SUBJECT: Docket 71-9297, Response to Request for Additional Information -
Certificate of Compliance No. USA/9297/AF-96 for Model No. TRAVELLER

Request for Additional Information
for the
Model No. TRAVELLER Package
Docket No. 71-9297

SCALE 1:5

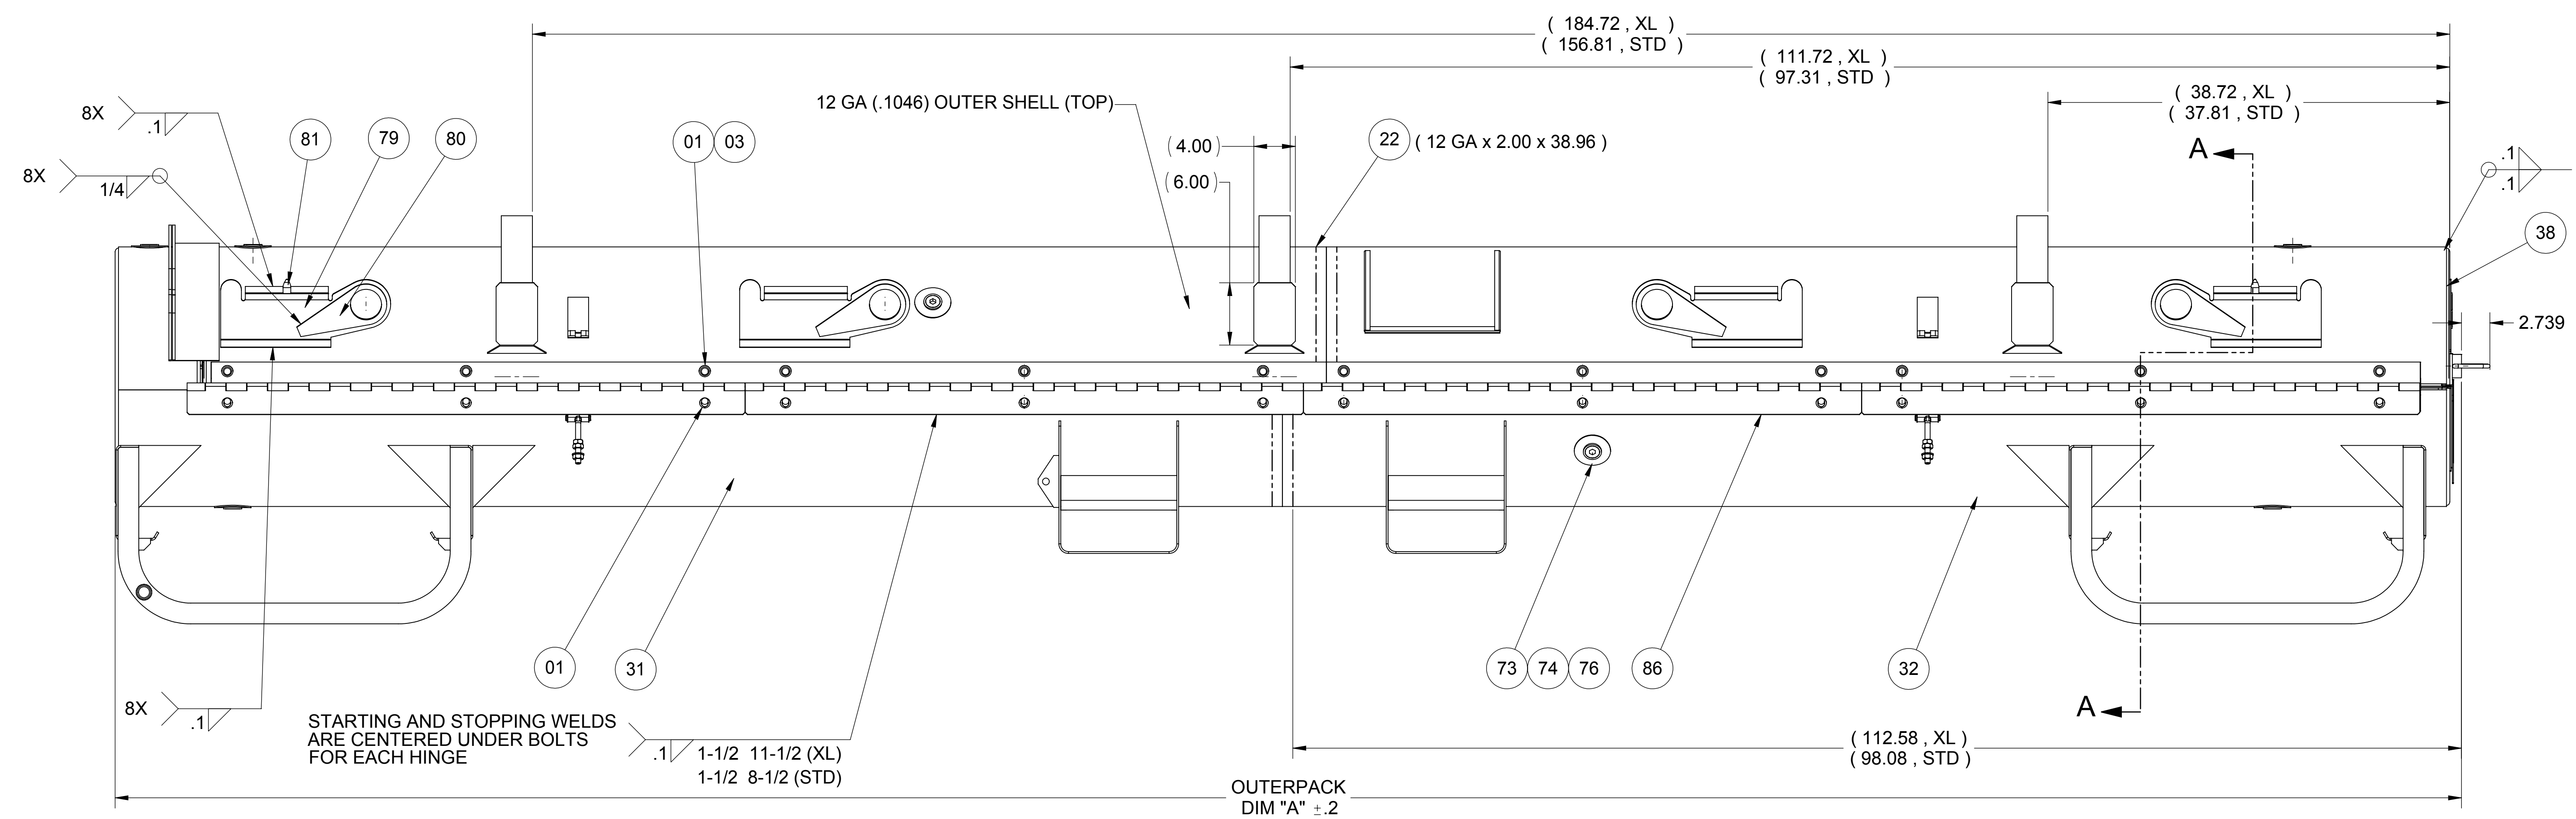
2. Revise DWG 10004E58, Rev. 6 to add sheet numbers to all pages. Staff noted that "Sheet 2 of 9" was missing from the second page of 10004E58, Rev. 6.

Drawing 10004E58, Rev 6. was corrected by adding "Sheet 2 of 9" and is included in another enclosure.
